Peer Review of Highlands Neighborhood Traffic and Pedestrian Safety Plan

FINAL REPORT

Prepared for:
Ada County Highway District

Prepared by:
SIX MILE ENGINEERING, PA

Figure 1-2. Traffic diverter at the intersection of Braemere Road and Curling Drive

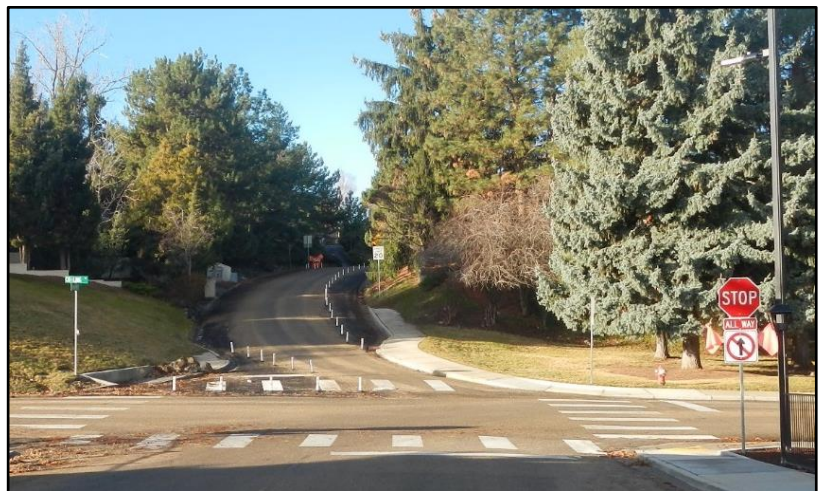
- 1.3. The diverter worked as intended, reducing cut-through traffic on Lower Braemere Road by approximately 930 vehicles per day (vpd), from 1,350 to 420 vpd, a reduction of nearly 70 percent.

- 1.4. The diverter re-routed cut-through traffic from Lower Braemere Road to Curling Drive. The increase in travel time for the re-routed traffic to drive from the intersection of Braemere Road and Curling Drive to the intersection of Hill Road and 15th Street along the diverted route is approximately 40 seconds on average during the peak hours compared to traveling the cut-through route.

- 1.5. Traffic re-routed by the diverter to Curling Drive increased vehicle congestion at Highlands Elementary School during student arrival and release times. The increase in congestion highlights the need to improve the method of student drop-off and pick-up. Even though the estimated cut-through traffic volume does not exceed ACHD minimum thresholds for mitigation on a collector street, ACHD should consider the following measures to improve pedestrian safety along the school frontage:

Based on our evaluation, the diverter has improved safety for pedestrians on Lower Braemere Road by reducing traffic volumes to levels that are more appropriate for the roadway's functional classification. By re-routing most of the cut-through traffic on Lower Braemere Road to Curling Drive, traffic from the upper Highlands neighborhood are driving the neighborhood's roadways using the correct roadway hierarchy progression. Traffic is driving from local streets to collector streets (Upper Braemere Road and Curling Drive), then to an arterial street (Bogus Basin Road), instead of using a local street (Lower Braemere Road) to traverse between collector streets.

On **Curling Drive at Highlands Elementary School**, the school drop-off and pick-up congestion is an operational and safety concern that ACHD and the school should address regardless of whether the diverter is in place or not. By organizing a safe and efficient student drop-off and pick-up plan, conditions can be made safer for students while improving overall traffic conditions around the school. The plan should designate student pick-up and drop-off zones and student waiting areas, vehicle loading protocol and waiting areas, and separate bus loading zones.

Figure 3-6. New all-way stop intersections

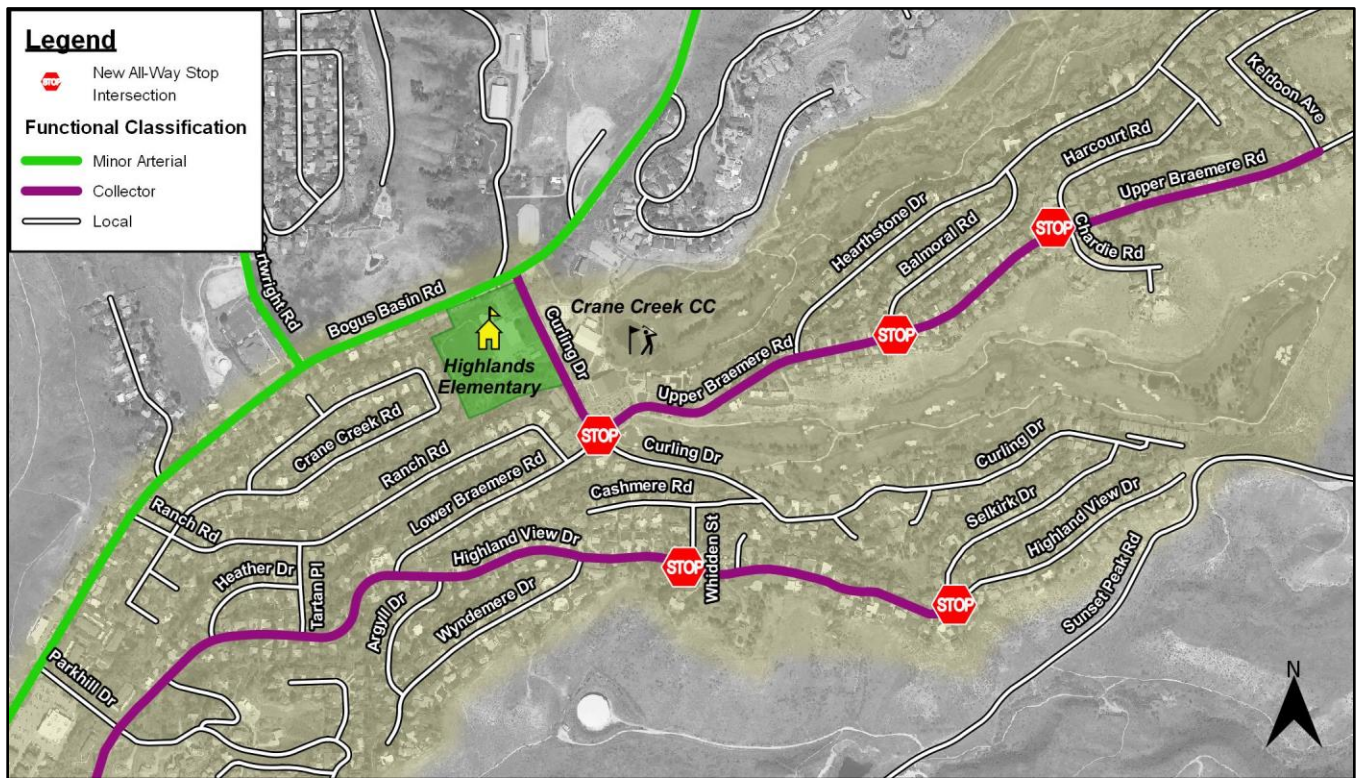
- 3.1. Stop signs were installed on Upper Braemere Road with the intended purpose of reducing vehicle speeds, according to the *Highlands Safety Plan*. However, according to the MUTCD, “stop signs should not be used for speed control.” ACHD should consider this guidance when identifying permanent traffic calming treatments.

- 3.2. The stop signs installed at the Balmoral Road intersection have helped reduce speeds by 3 mph in the roadway segment between Balmoral Road and Hearthstone Drive. During our field observations, 12 percent of drivers did not stop at the intersection.

- 3.3. Speed measurements in the vicinity of Harcourt Road/Chardie Road intersection after stop sign installation were obtained too close to the Keldoan Avenue intersection to be comparable to measurements taken prior mitigation so the speed control performance cannot be determined. During our field observations, 19 percent of drivers did not stop at the intersection.

- 4.1. Stop signs were installed on Highland View Drive with the intended purpose of reducing vehicle speeds, according to the *Highlands Safety Plan*. However, according to the MUTCD, “*stop signs should not be used for speed control.*” ACHD should consider this guidance when identifying permanent traffic calming treatments.

- 3.4. ACHD should re-evaluate the use of stop signs as a permanent measure for traffic calming. Permanent traffic calming measures identified in the *Highlands Safety Plan* and presented to the public at the open house meeting should be re-considered. ACHD should

consider retaining the stop sign installations as a temporary measure during construction of Highlands Cove subdivision or until a permanent measure is implemented.

- 3.5. ACHD should consider installing speed limit signs within 100 to 200 feet downstream of all approaches at the current all-way stop-controlled intersections to remind drivers of the speed limit.
- 3.6. ACHD should consider increasing the 20 mph posted speed limit to 25 mph on Upper Braemere Road from Curling Drive to east of the Crane Creek Country Club, a length of approximately 800 feet. The increase would better reflect the speed that motorists are currently driving on this segment of road – 85th percentile speeds of 31 mph – and would be consistent with the 25 mph posted speed on the remainder of Upper Braemere Road and Curling Drive. In considering the speed limit change, an evaluation of sight distance for the golf cart crossing and ball-bank indicator test results for the roadway curves should be conducted.

- 4.4. ACHD should re-evaluate the use of stop signs as a permanent measure for traffic calming. Permanent traffic calming measures identified in the *Highlands Safety Plan* and presented to the public at the open house meeting should be re-considered. ACHD should consider retaining the stop sign installations as a temporary measure during construction of Highlands Cove subdivision or until a permanent measure is implemented.

- 4.5. ACHD should consider installing speed limit signs within 100 to 200 feet downstream of all approaches at the current all-way stop-controlled intersections to remind drivers of the speed limit.
